Subject: Arkansas Nuclear One - Unit 2
Docket No. 50-368
License No. NPF-6
Additional Information on Proposed Risk-informed License Change Regarding
Steam Generator Tubing (TAC NO. MA8418)

Additional Information in Support of Risk-informed License Change

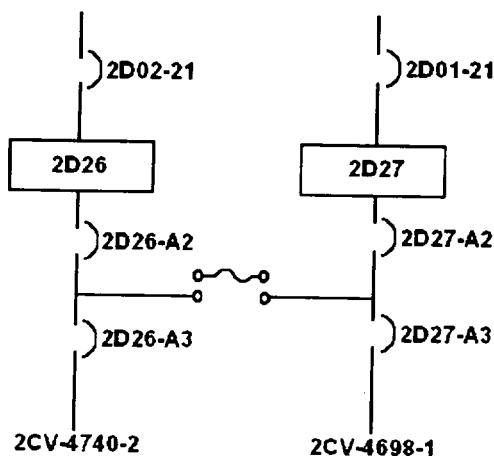
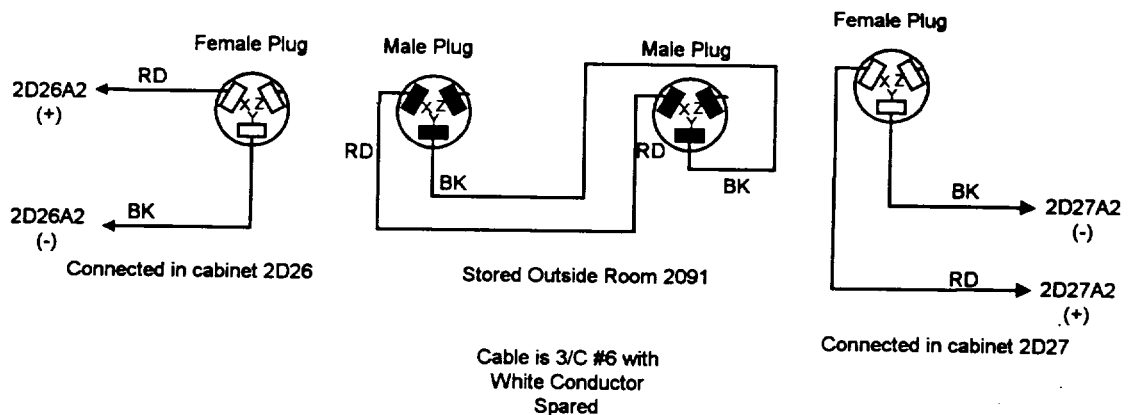
1. Provide a description of the plant changes required to support the new depressurization procedure.

During accident scenarios with a loss of one emergency train (both AC and DC), the RCS cannot be depressurized using either ECCS vent or LTOP valves. The modification provides for the installation of equipment to facilitate temporary power to the ECCS vent valves.

The modification provides a simple means for both ECCS vent valves to be energized from the opposite DC bus using a temporary connection to permanently mounted twist-lock plugs. The permanently mounted twist lock plugs will be connected to the load sides of 2D26 breaker 2D26-A2 and 2D27 breaker 2D27-A2.

When loss of a DC bus occurs, the procedures direct the control room to dispatch the Emergency DC Crossconnect Watch to the 2B53 room to STANDBY for further instruction. When the need to depressurize the RCS is identified, procedure guide the control room operator to open the ECCS vent valve on the still energized bus. The Crossconnect Watch then opens the DC bus supply breaker to the de-energized MCC as directed by the control room operator (2D26 or 2D27). Next, the Crossconnect Watch will open the upstream feeder breakers to both ECCS vent valves. The Crossconnect Watch will then connect the extension cable. Once the cable connectors are locked in place, the feeder breaker to the ECCS vent valve on the energized bus is closed sending DC power to the opposite train vent valve. The second ECCS vent valve is then opened from the control room commencing depressurization of the RCS.

CDF of Mp Values at Beginning of Cycle Conditions for ANO2 (Case 1')

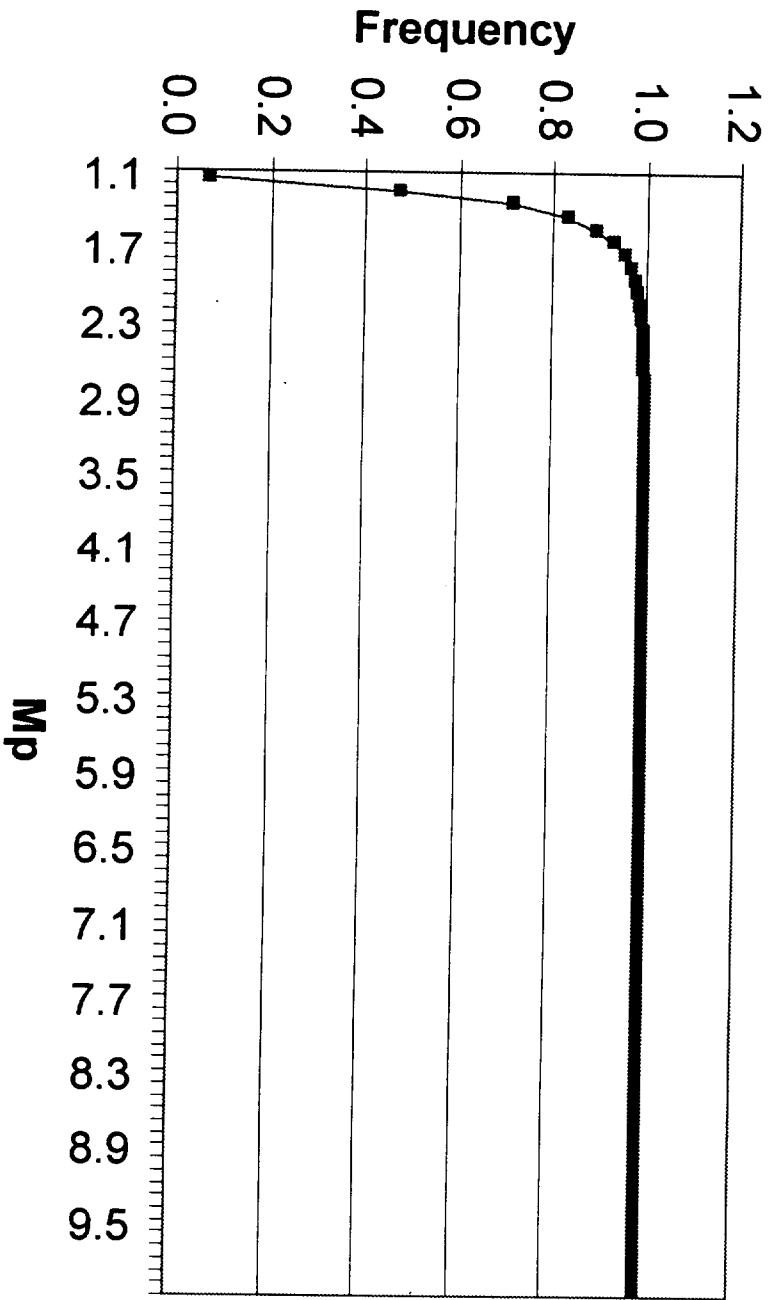
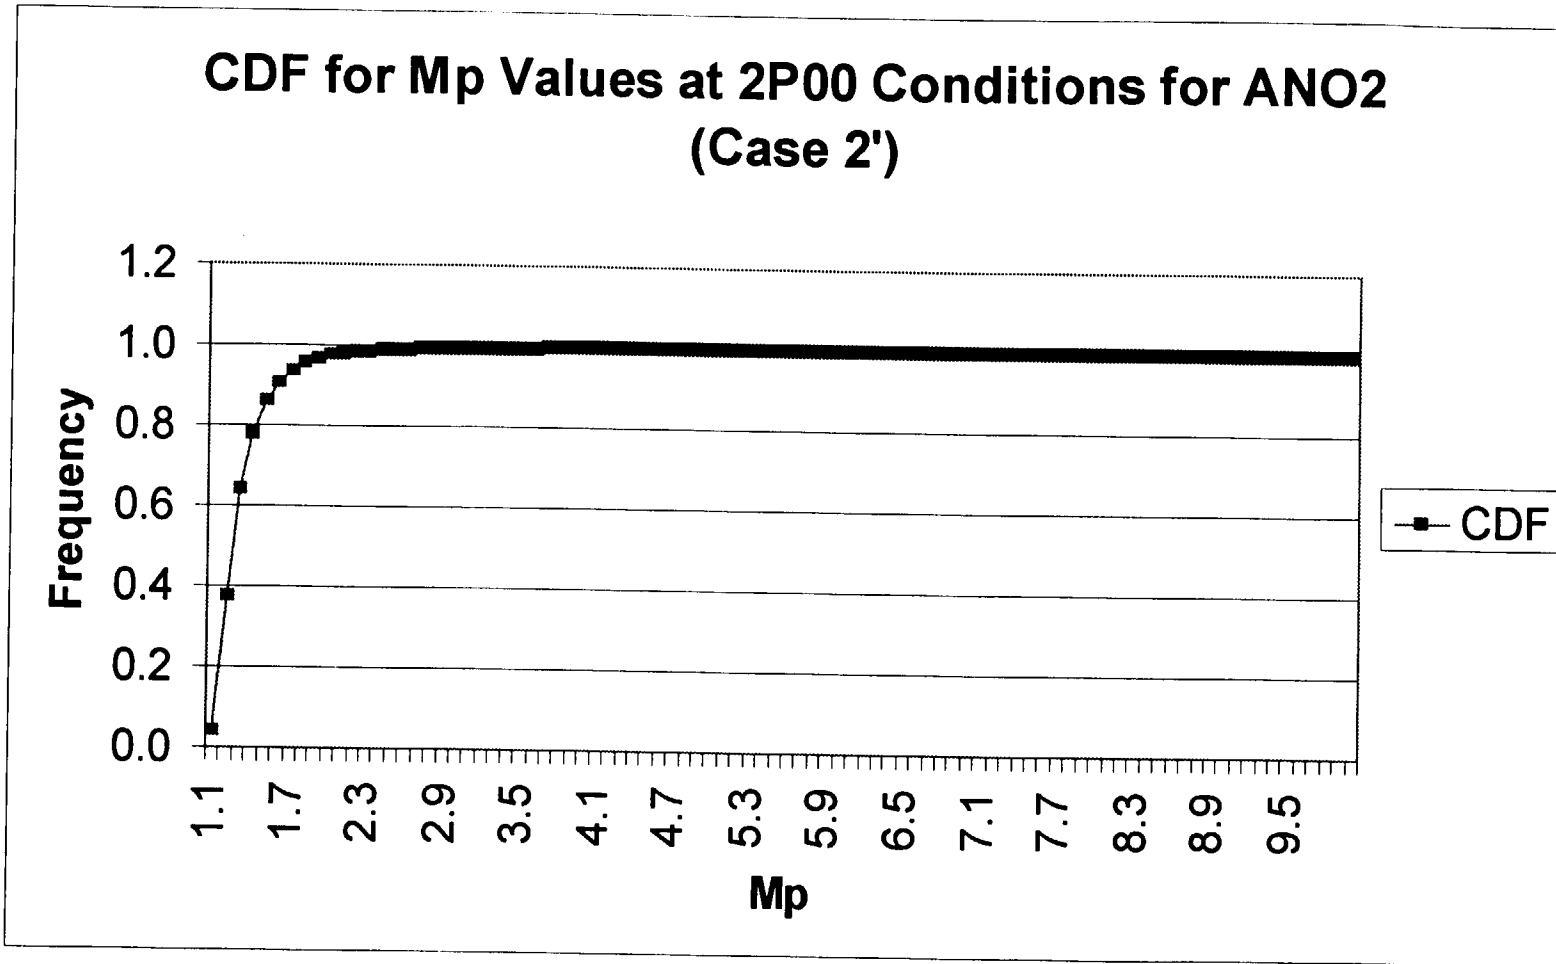
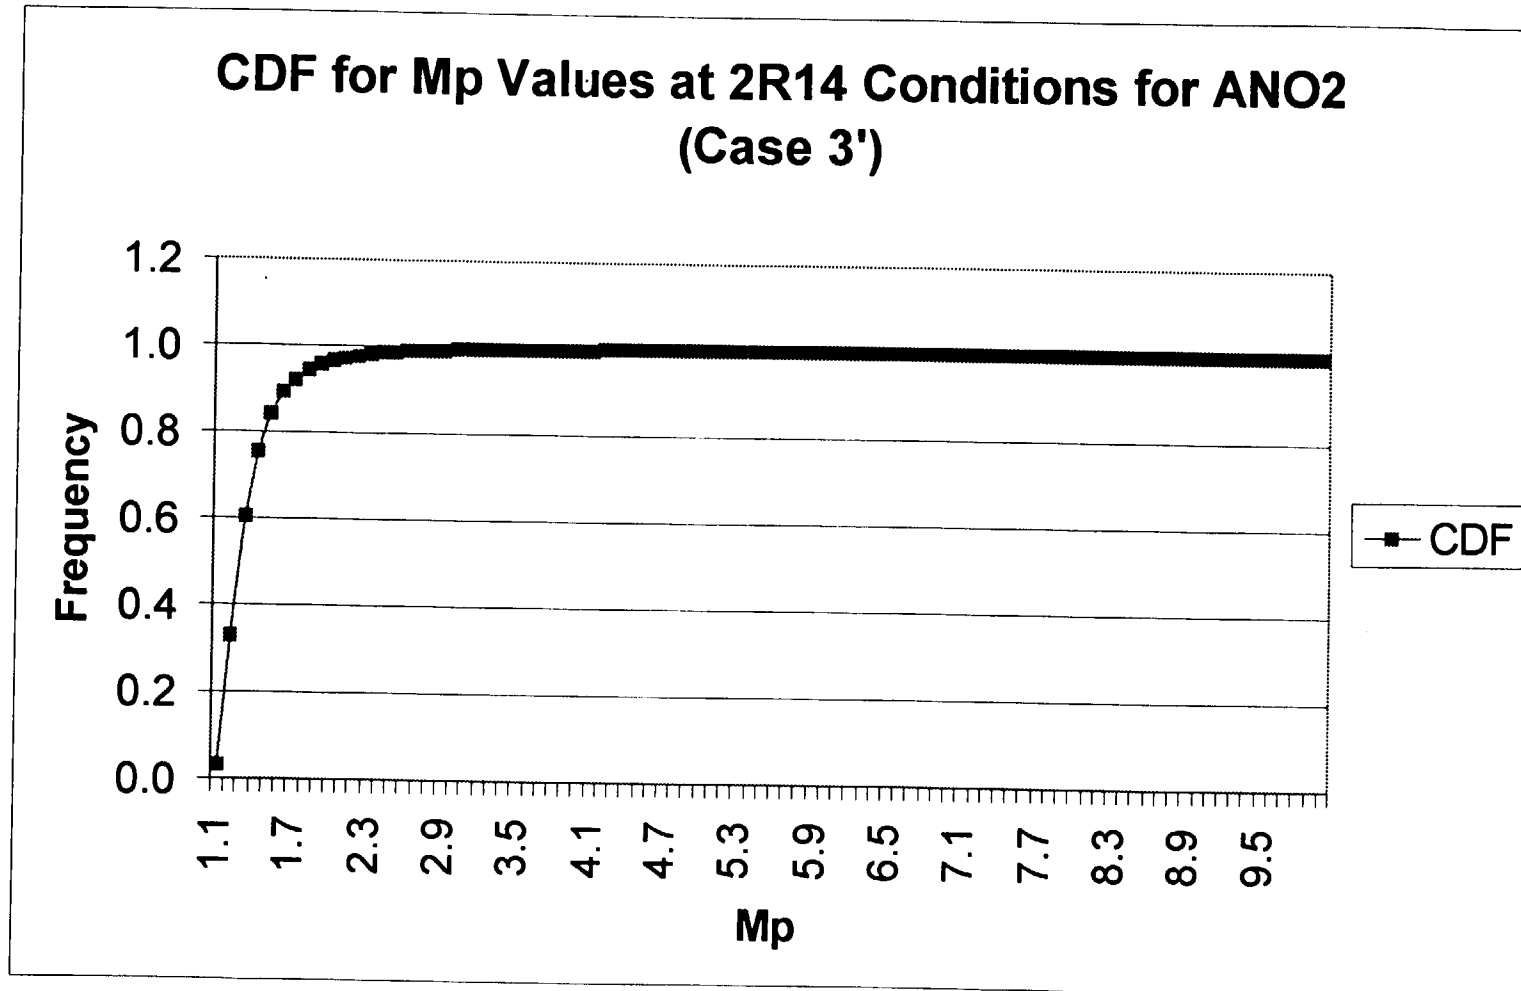
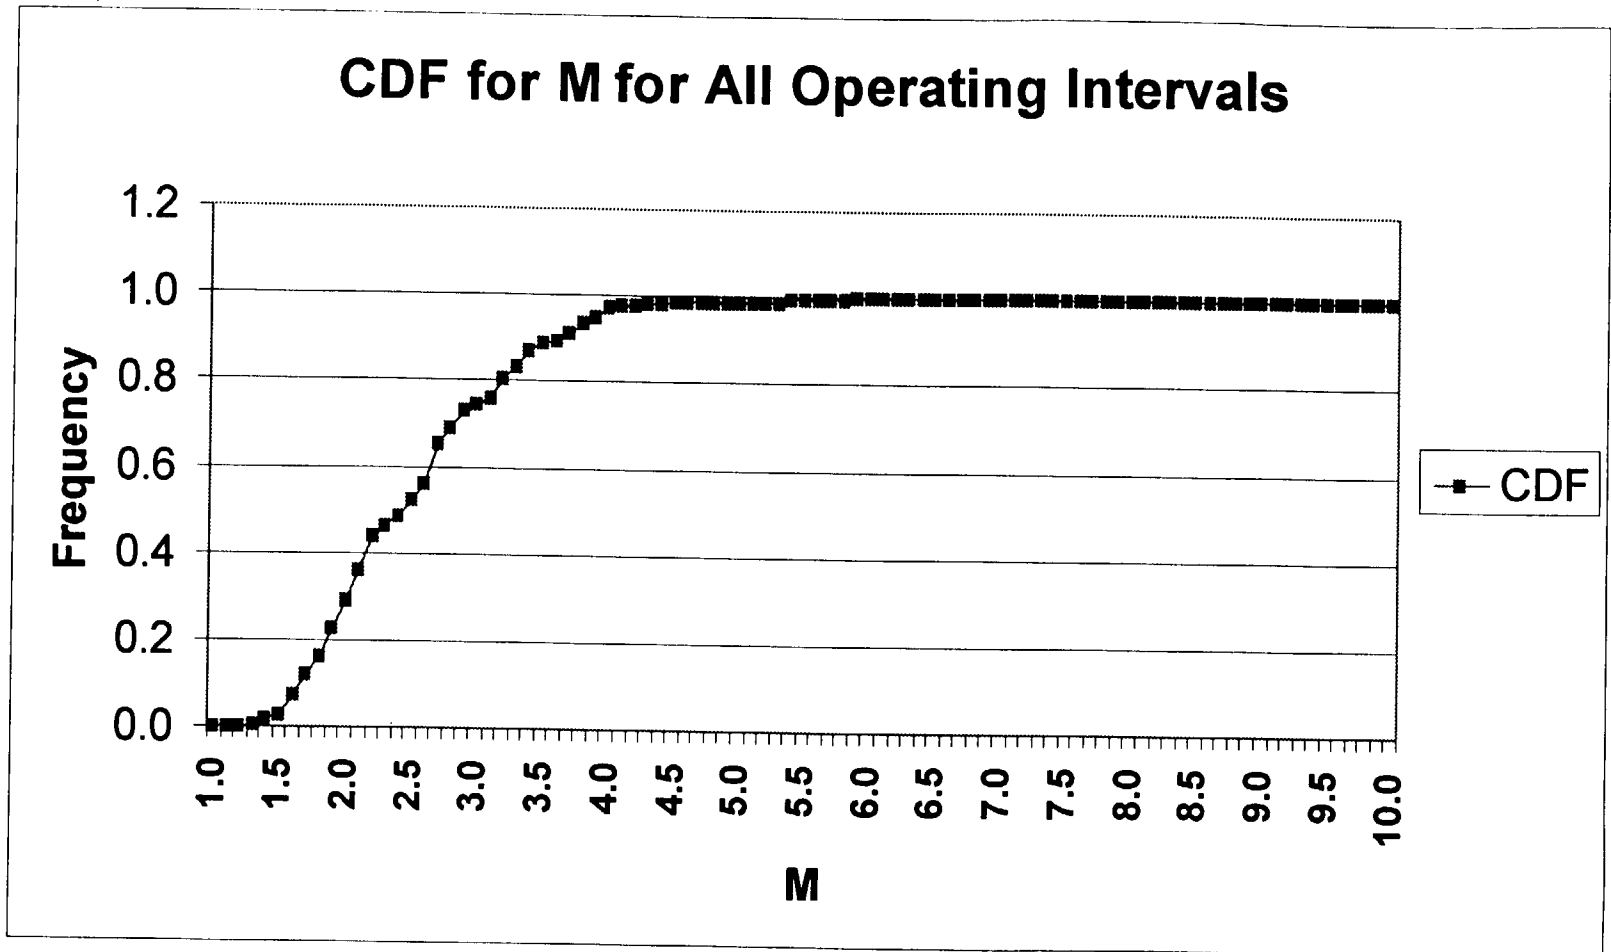
11. Using the most recently provided estimates of flaw growth rates and the probability of detection as a function of flaw size during your most recent inspection (2P99), provide the probability distributions for the stress magnification factors for partial through-wall cracks (m_p) and through-wall cracks (m) for each of these 3 points in time during your current operating interval: 1) start-up the fall of 1999, 2) June 15, 2000 without inspection, and 3) September 15, 2000, without inspection.

The following four tables of data are the M_p and/or M values for the following predicted conditions:

Also attached are the probability distribution graphs for the data listed above.
